Memorandum

Subject: Addendum 1 to the Final Corrective Measures Implementation Plan for Groundwater
Landfill 3, Parcel 80(6) and Fill Area Northwest of Reilly Airfield, Parcel 229(7)
McClellan, Anniston, Alabama
Geosyntec Project: GR4116

Preliminary Remedy Overview
McClellan, Anniston, AL

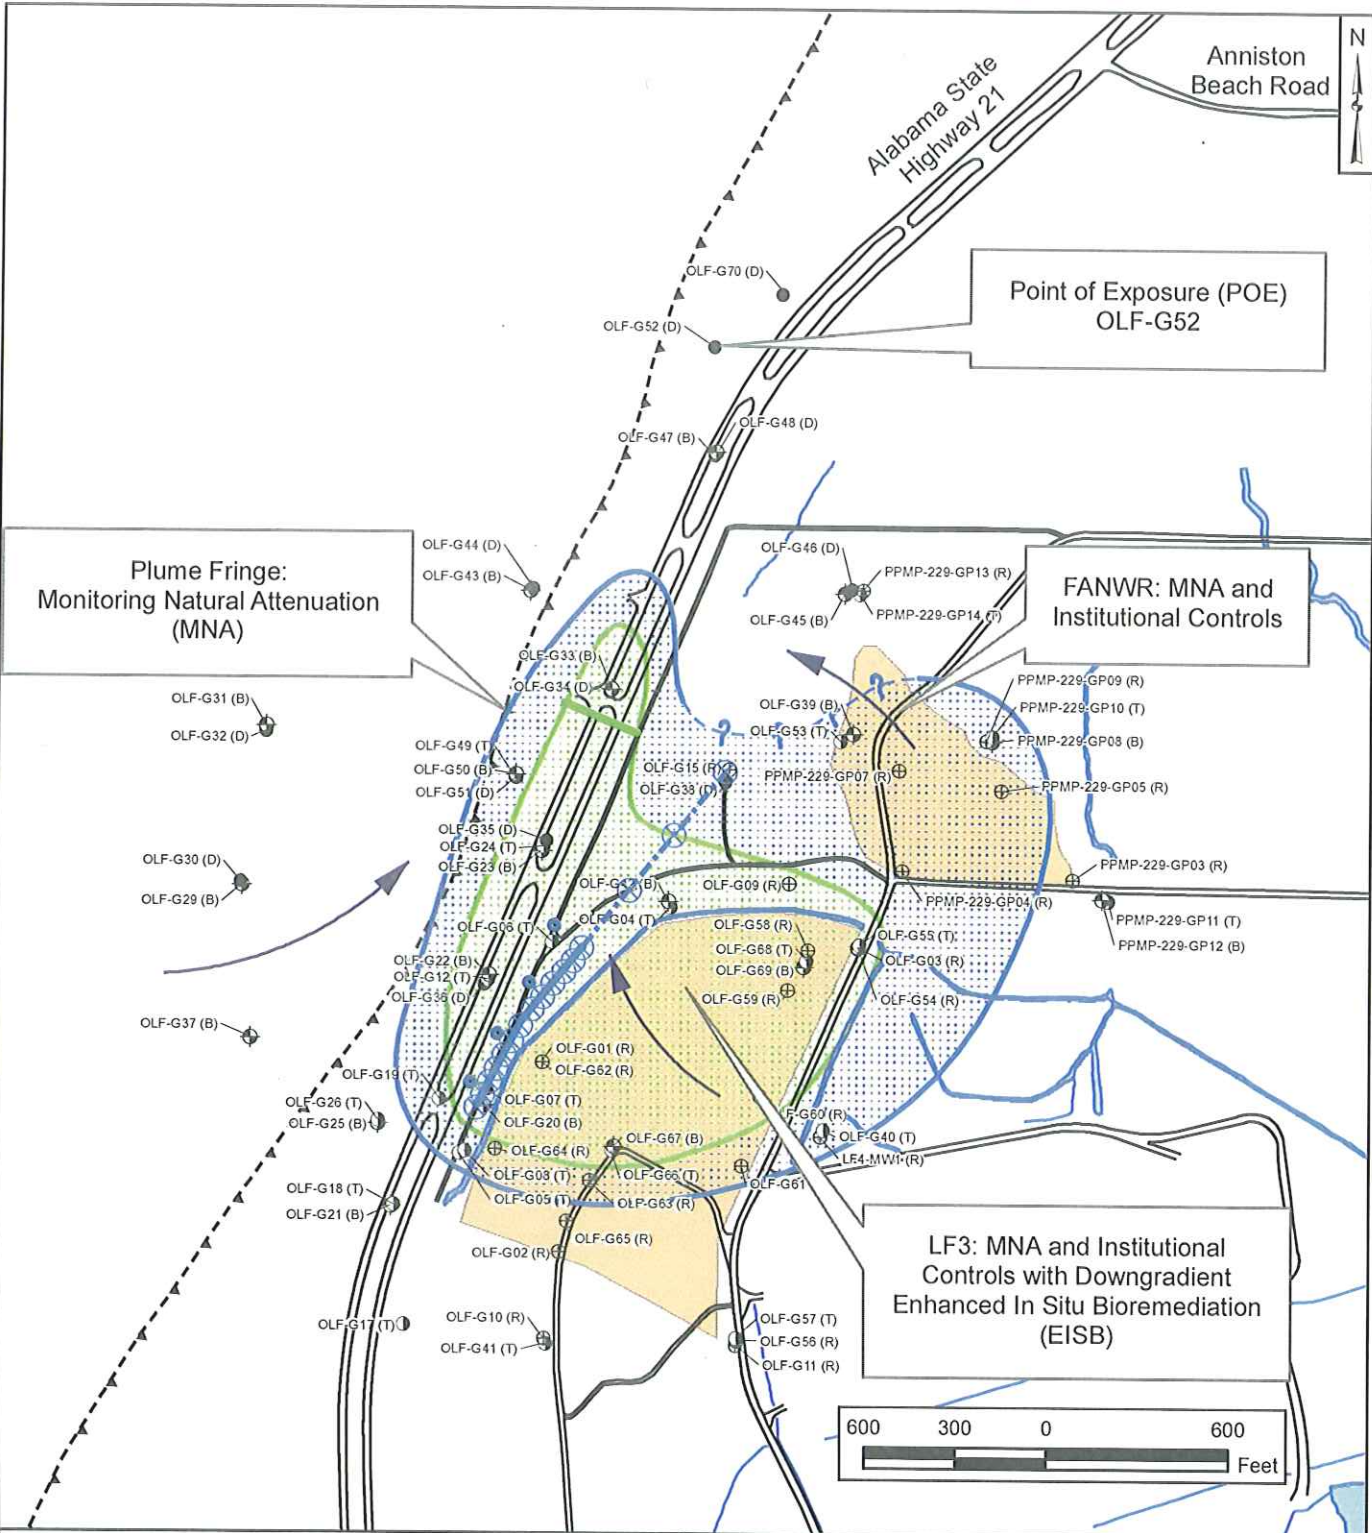
The revised EISB conceptual design focuses primarily on an optimized field implementation approach and continues to use lines of injection wells that transect the primary downgradient flow path for COCs. Figure 1 presents the revised EISB conceptual design. The initial transect will be installed immediately downgradient of LF3 in two phases. Phase 1 will consist of: (i) 16 injection wells sited in the southwestern end of the transect and screened in the COC-impacted zone of the aquifer; and (ii) four performance monitoring wells installed immediately downgradient of the injection transect. Based on results of the performance monitoring data, the Phase 1 transect will be extended, as necessary, to the northeast in a Phase 2 installation

deployment. Up to 12 additional injection wells and 4 additional performance monitoring wells will be installed.
